Re: Roadrunner Car Shop, 1515 Coors Blvd NW

Temporary Certificate of Occupancy – Transportation Development (J11-D027)

Re: Roadrunner Car Shop / Emissions Addition, 1515 Coors Blvd NW, Traffic Circulation Layout

Grading and Drainage Plan Road Runner, J11/D027

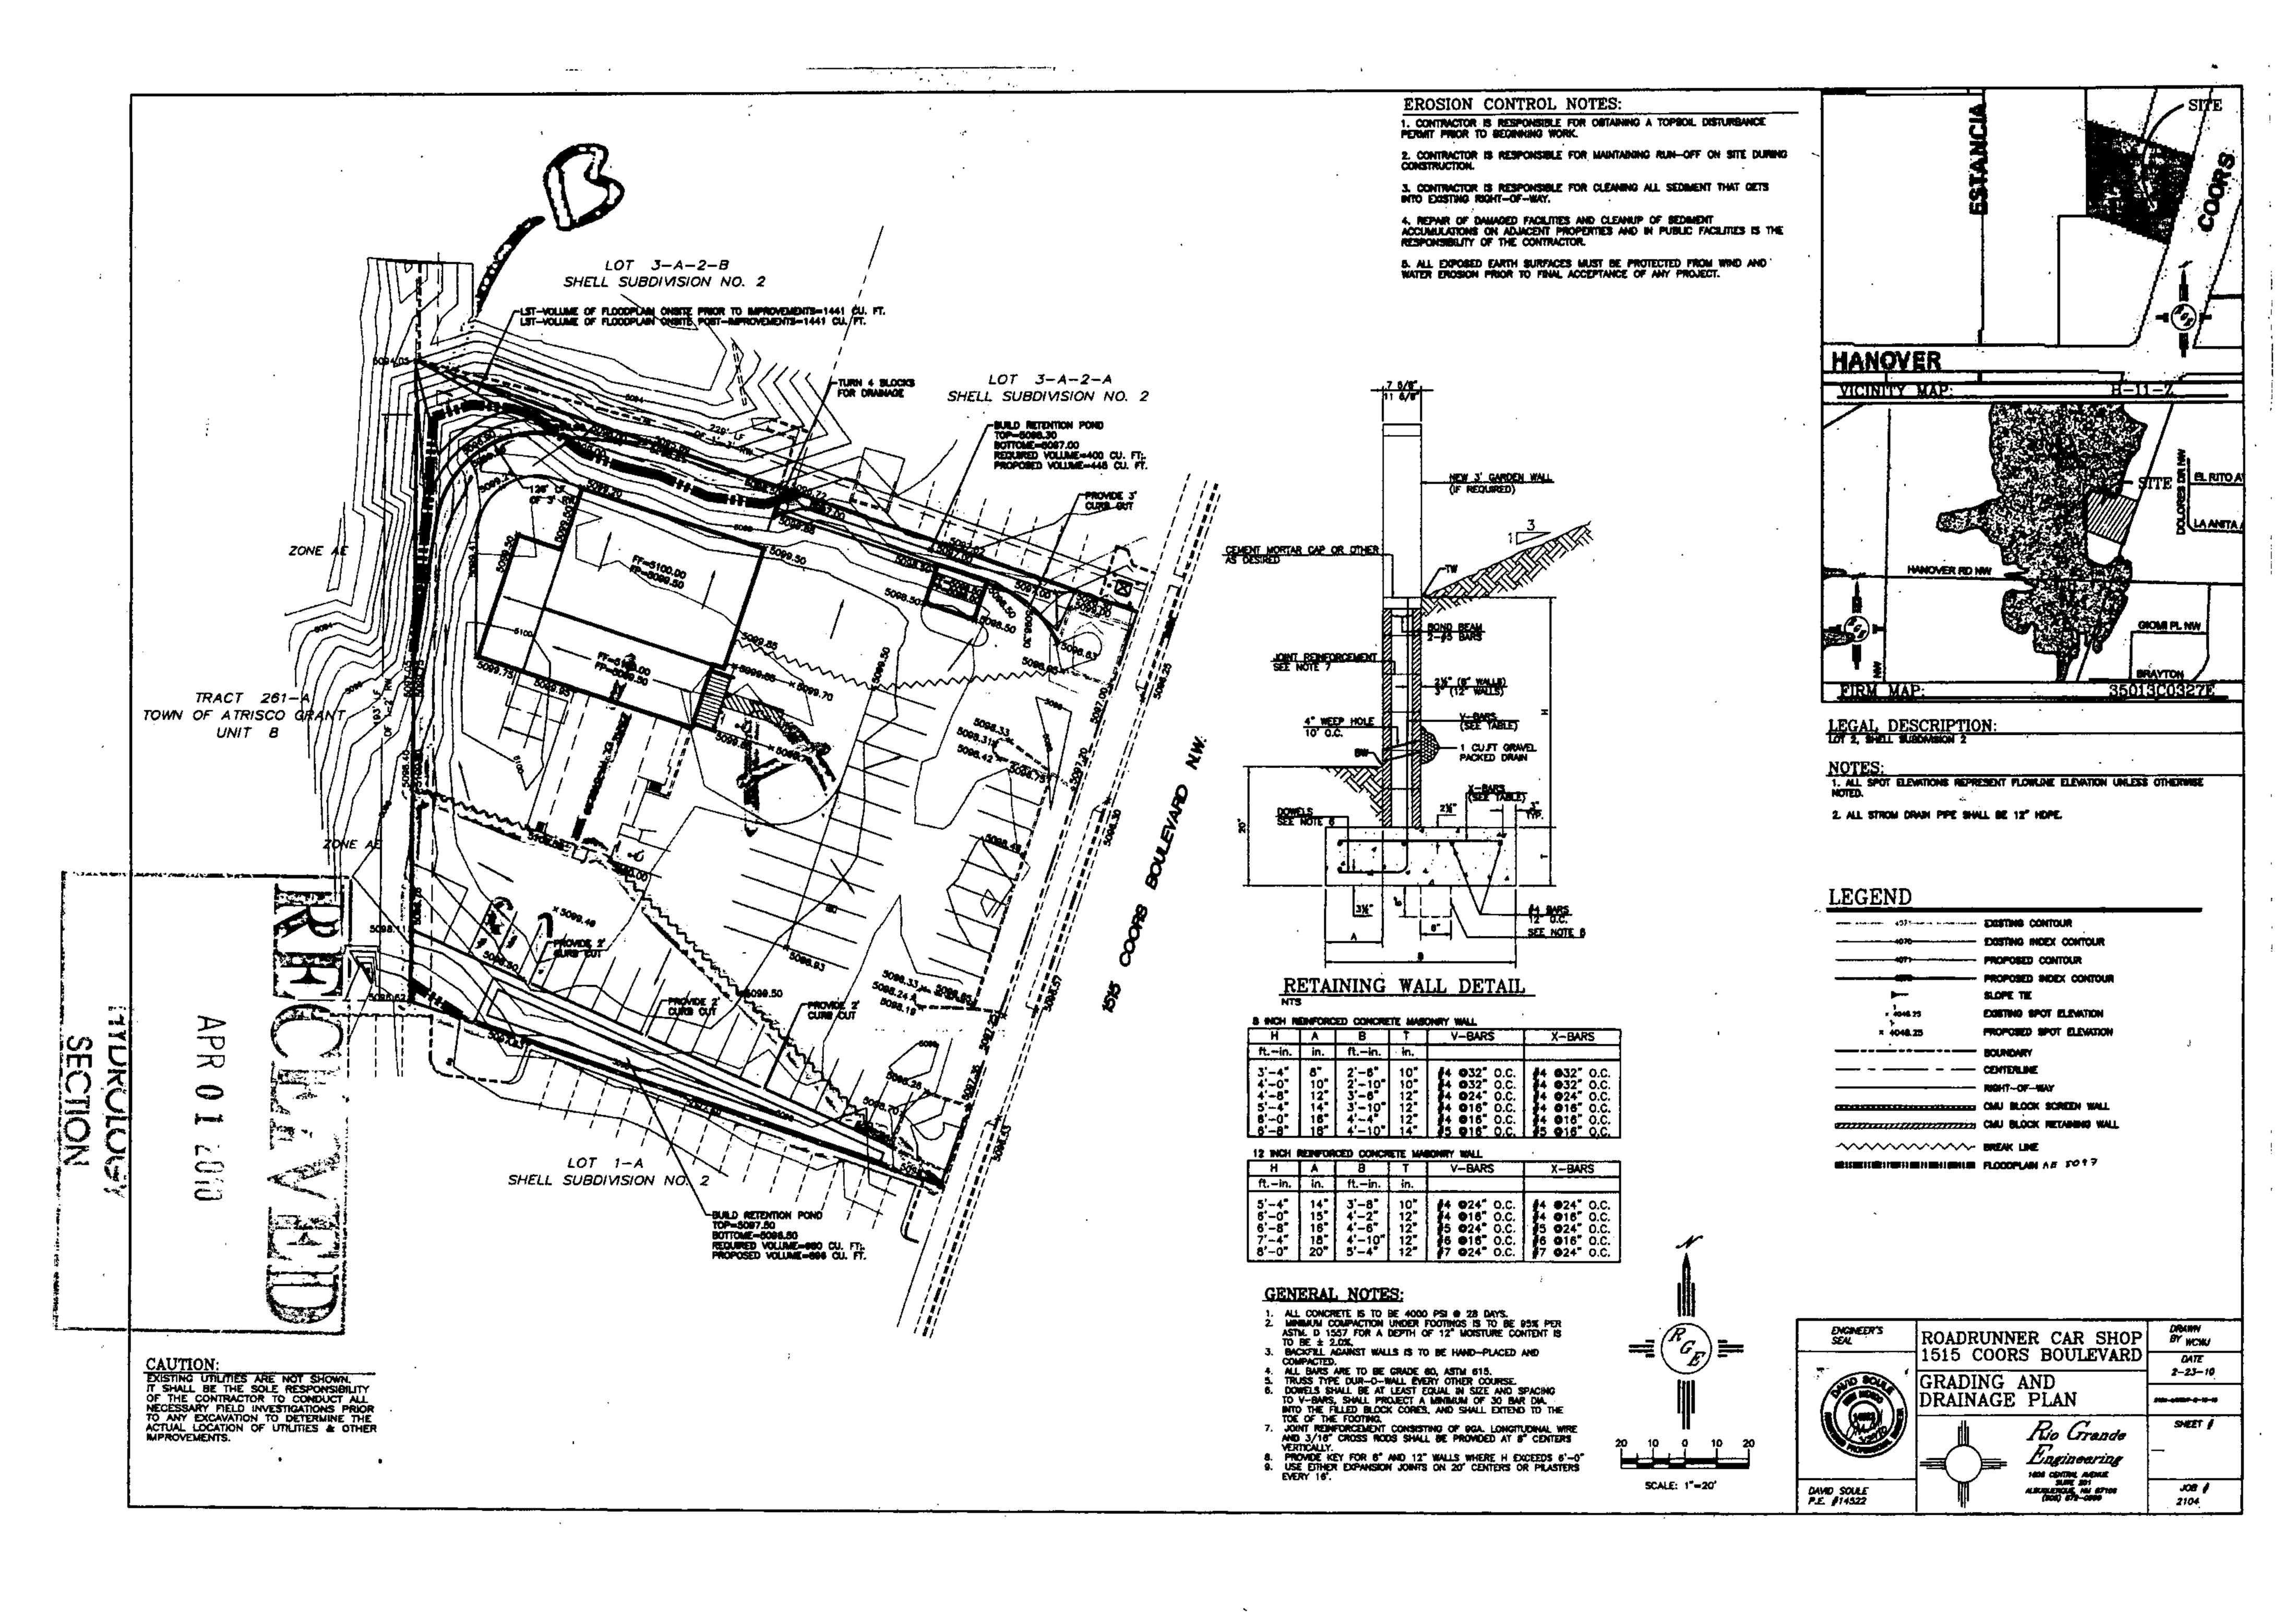
How is the flow leaving site

Can the increase in flow be captured in the new landscape areas.

1. How is the flow leaving the site?

2. Can the increase in flow be captured in the new Landscaping areas?

I believe this comment is do similar elevations at the landscape area at NE corner, We have raised the landscape area to make sure the water leaving the new harvesting pond enters the parking lot and drains out the existing driveway. Now all flow leaves site at driveway. The ponding at NW corner stays since it is being built to compensate for existing flood plain.

The SW portion of the site has been modified to be captured in a 1' deep harvesting pond. This pond will retain the 100-yr 6-hour volume. An additional pond has been added at the north landscape area, now the site discharges .27 cfs less than historical.
